**PUBLIC UTILITIES COMMISSION**505 VAN NESS AVENUE
SAN FRANCISCO, CA 94102-3298**FILED**08-15-08
11:08 AM

Order Instituting Rulemaking to Establish
Uniform Construction Standards for Pole-Top
Antennas.

Rulemaking 07-12-001
(Filed December 6, 2007)

**DECISION ADOPTING UNIFORM CONSTRUCTION
STANDARDS FOR POLE-TOP ANTENNAS**

~~Figure 94.1~~

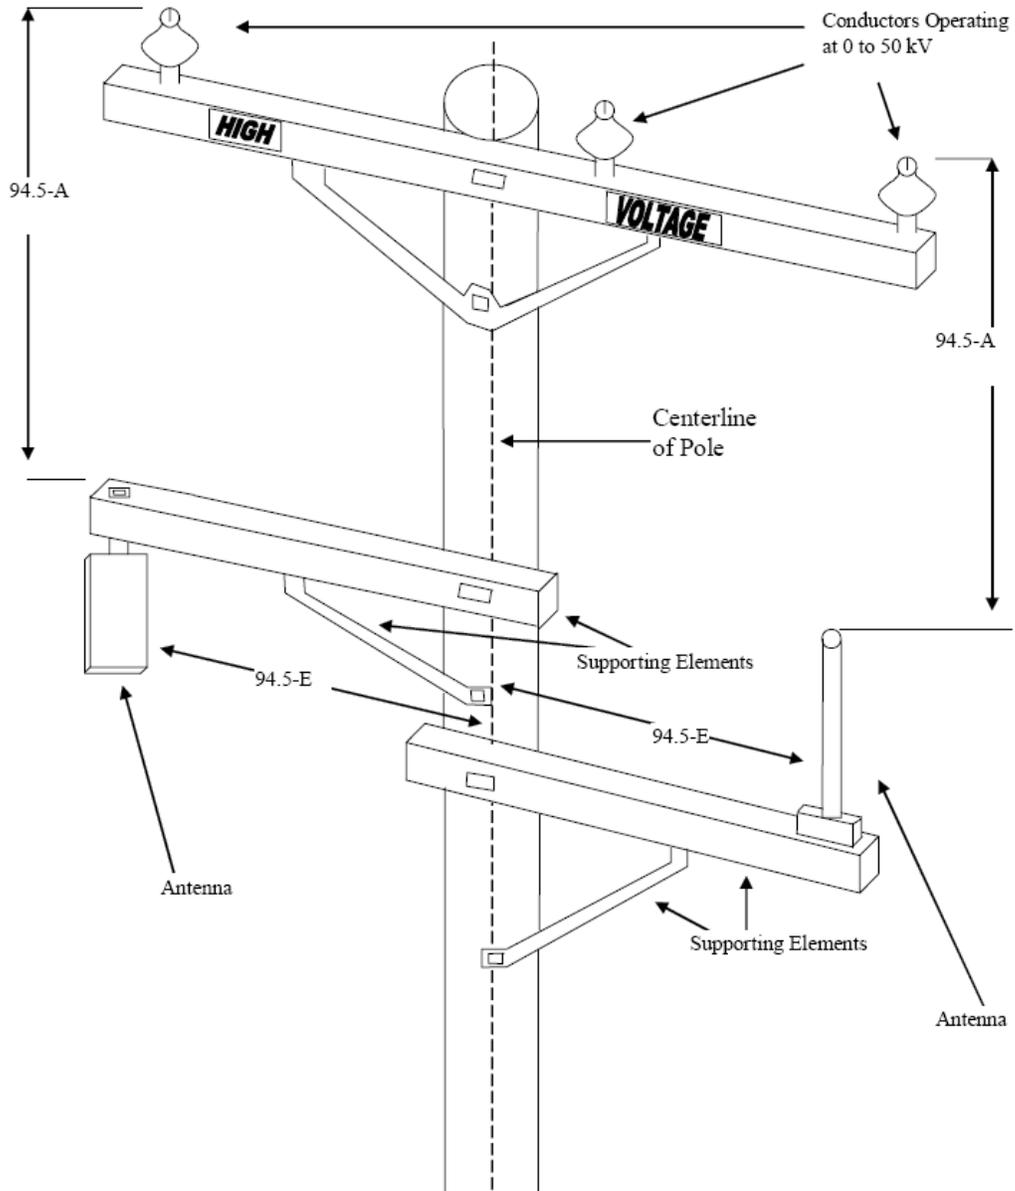
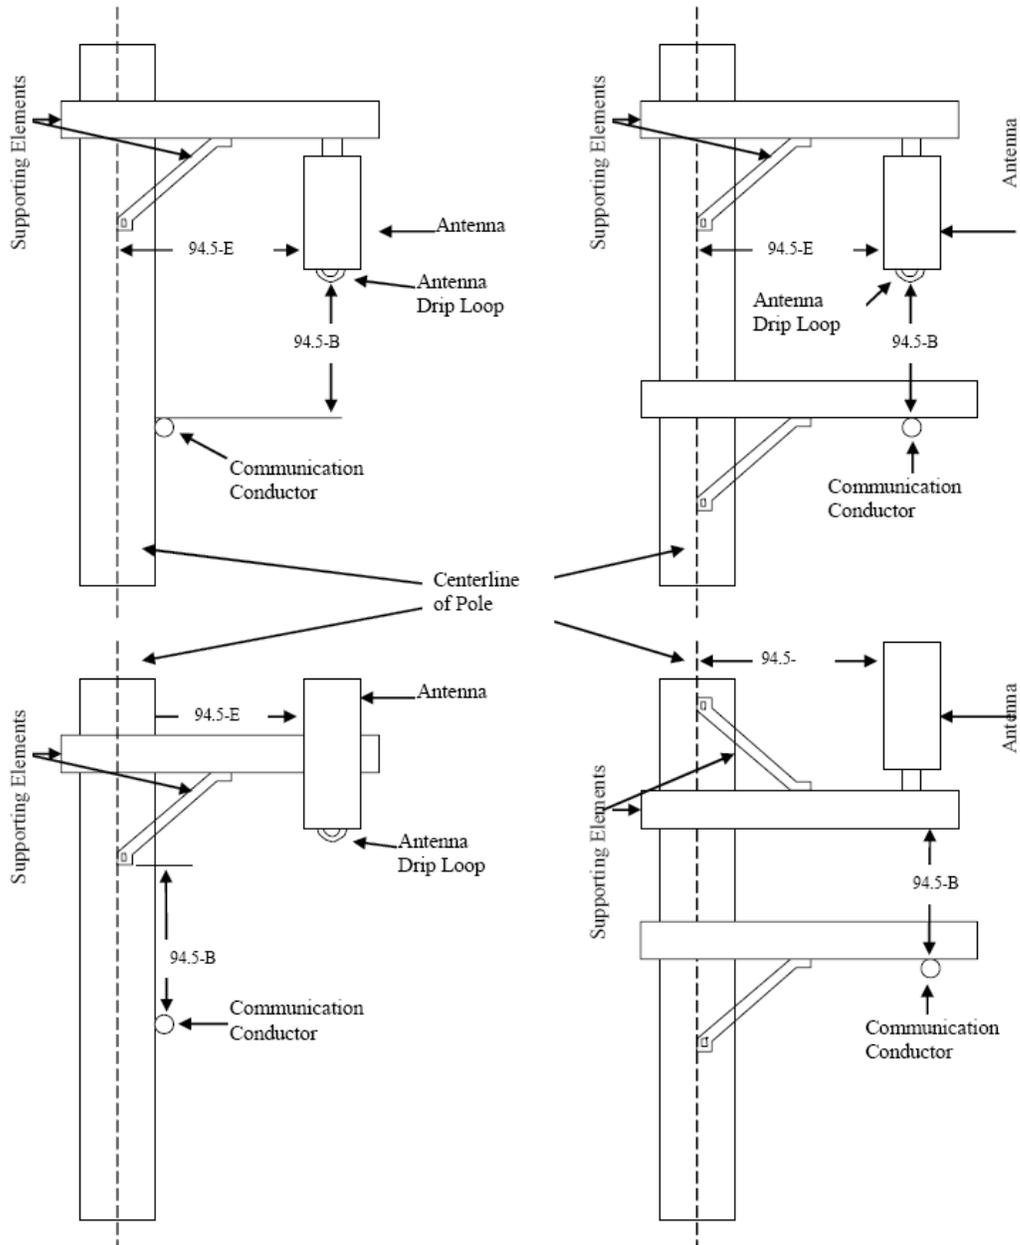
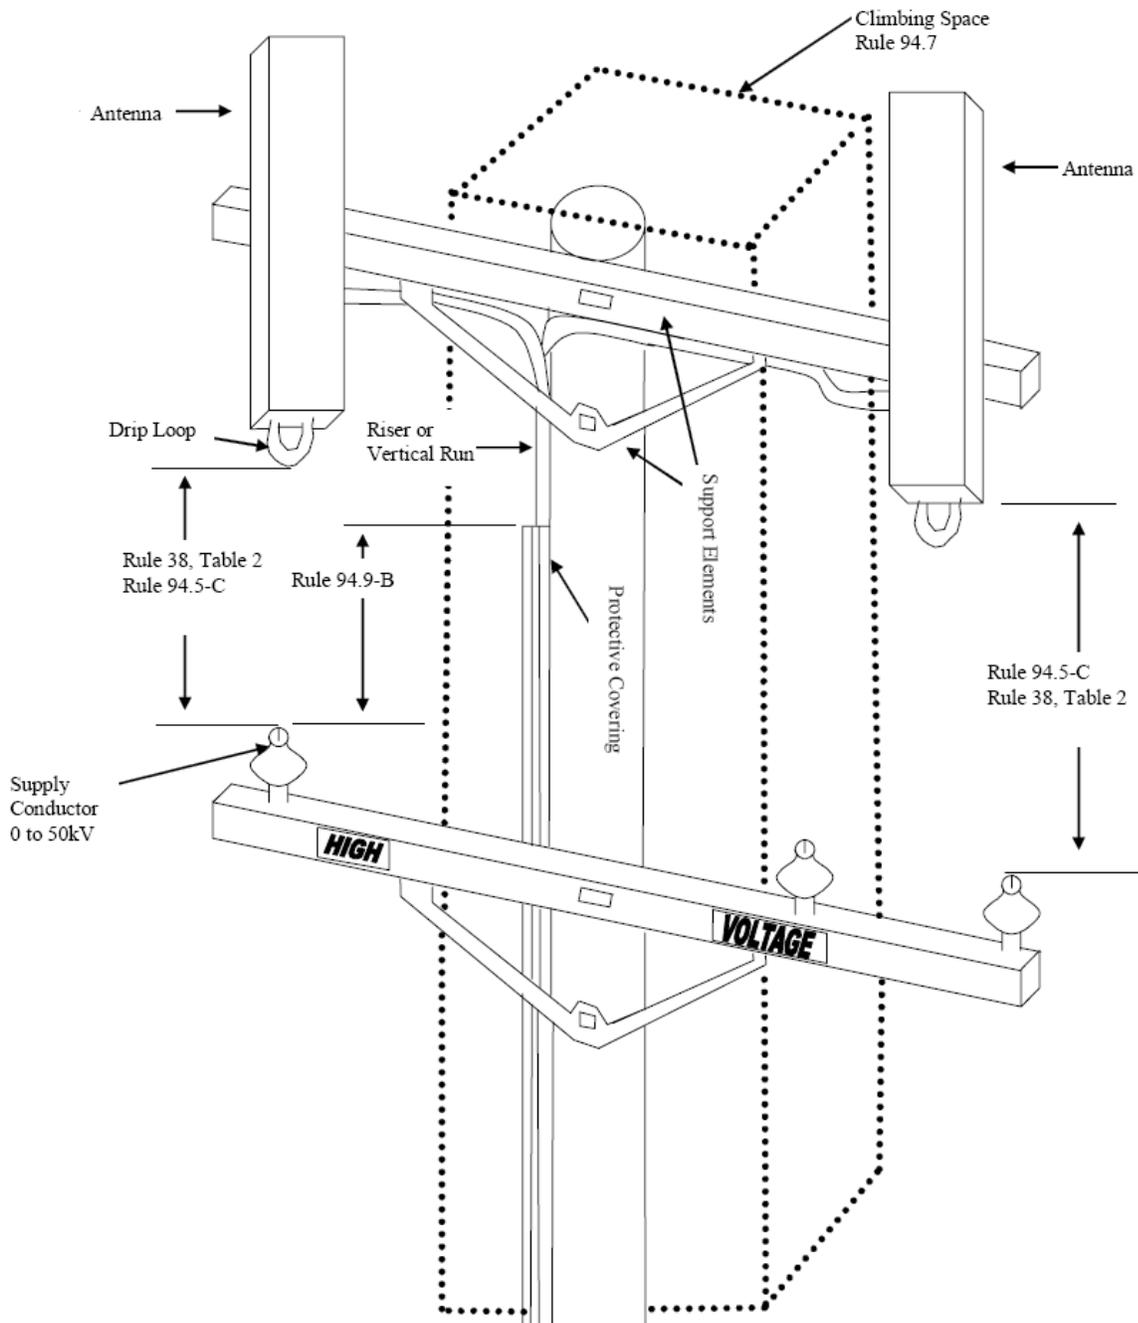
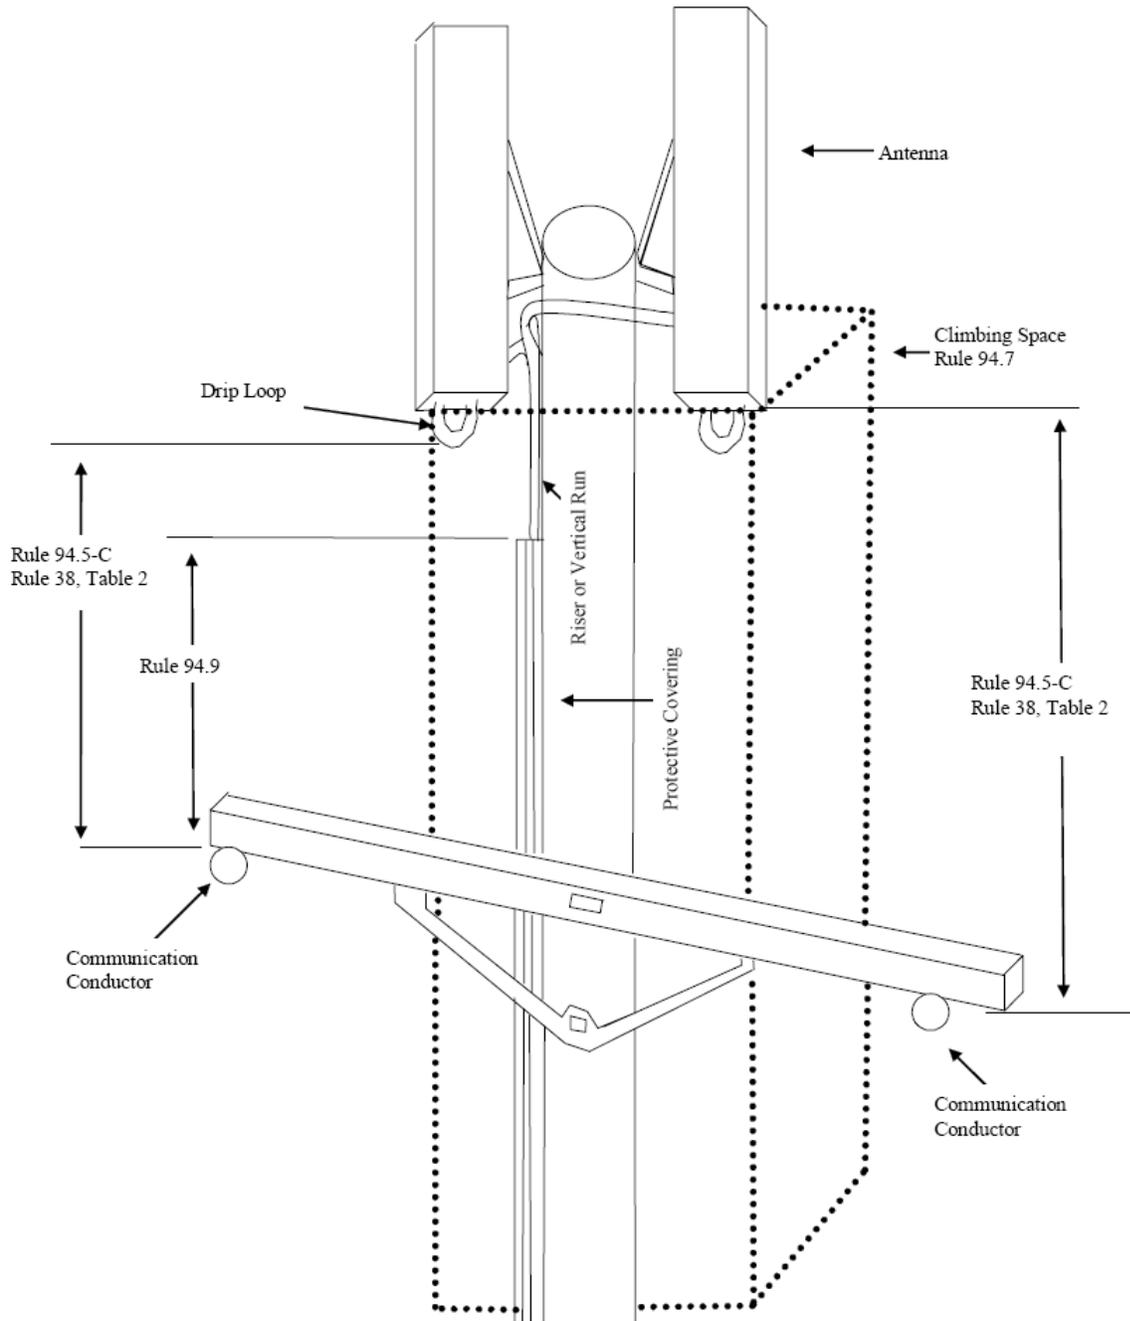
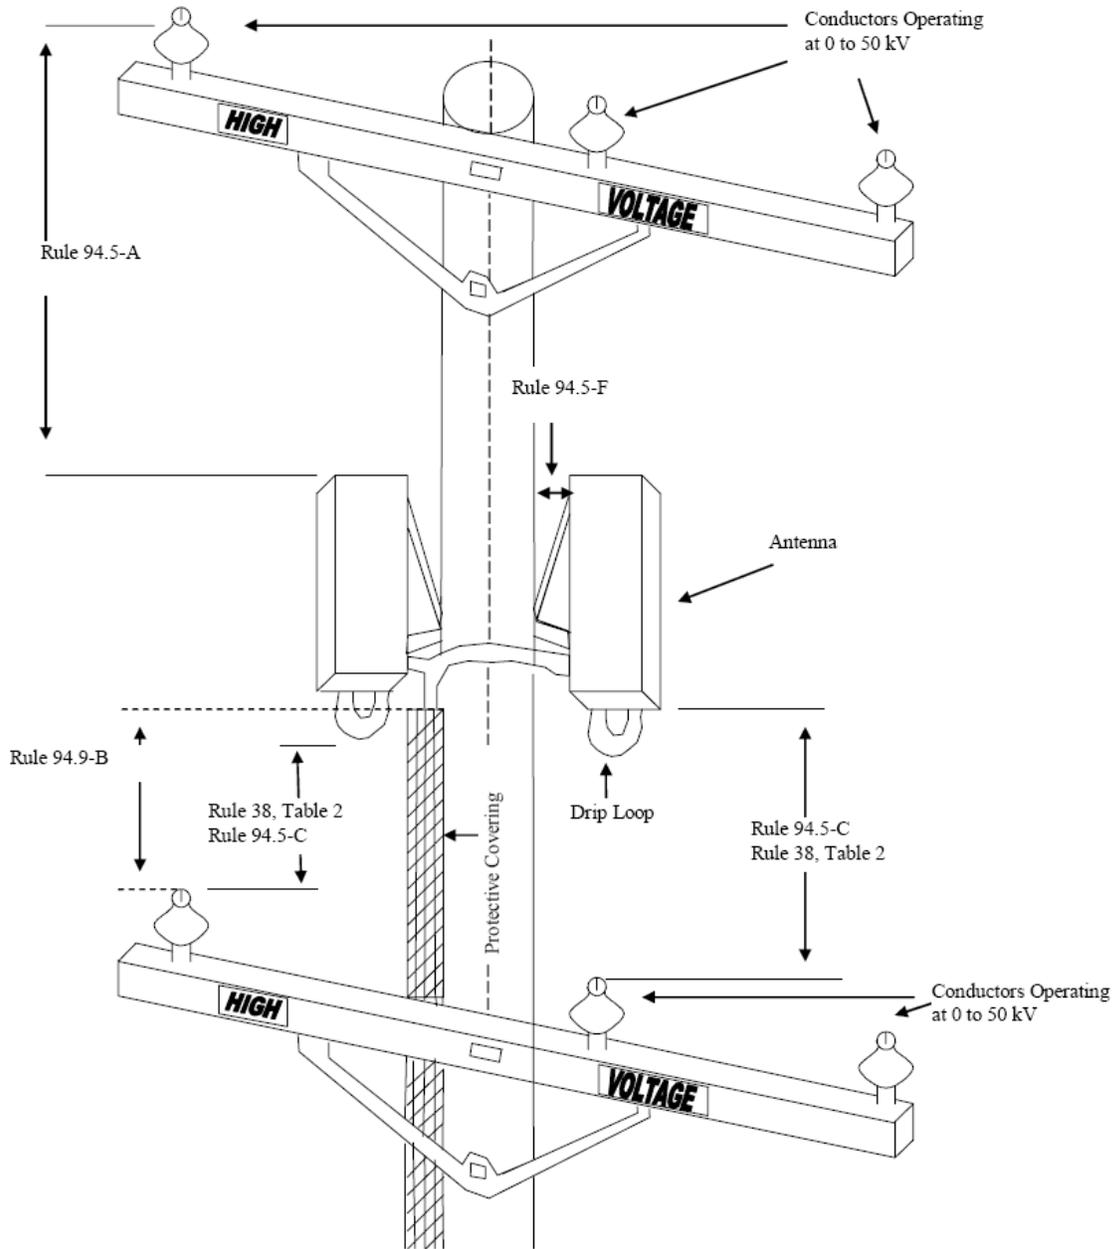
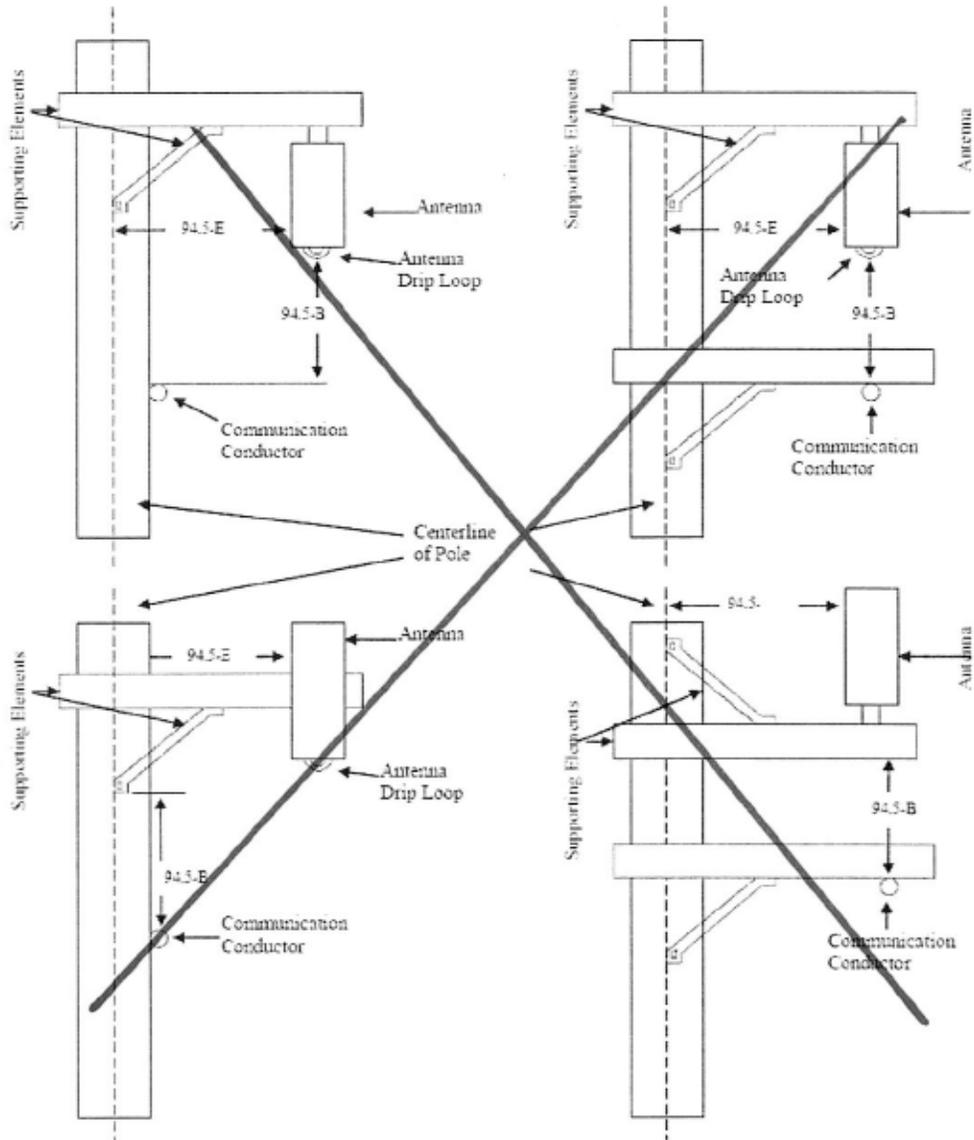
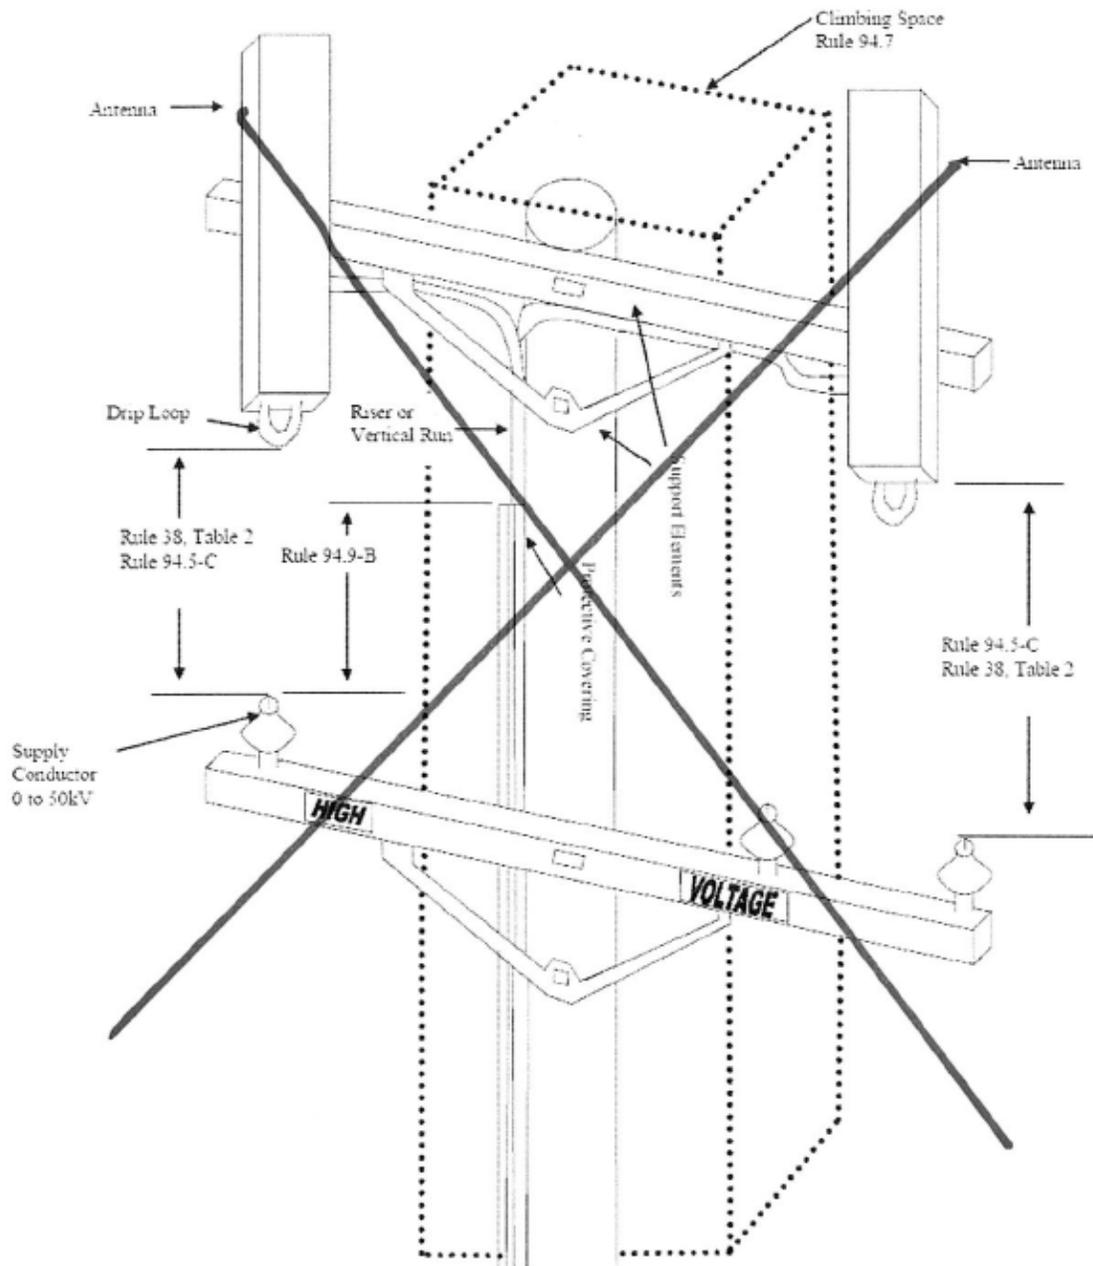
Finally, the TCR proposes to replace four existing diagrams with one new diagram labeled Figure 94.1. The new diagram illustrates in one place all of the vertical and horizontal clearances mandated by the revised Rule 94.

During the afternoon session, attendees discussed revisions to Figures 94.1 - 94.5 and concluded that a new Figure that encapsulates the variety of wireless antenna installations above and below supply and communication lines on a joint-use utility pole would be preferable to five separate Figures.

Also, the references to multiple Figures (94.1 – 94.5) were replaced with references to a new composite Figure 94.1.

(PRC #2) and Rule 92.1-F2 (PRC #3). Before adjourning, Raymond Fugere (CPSD) offered to revise the Figures 94.1 - 94.5 and Sam Stonerock (SCE) offered to organize the proposed workshop revisions to PRCs 1-4. Both the Figures and revisions were subsequently distributed to the Parties.
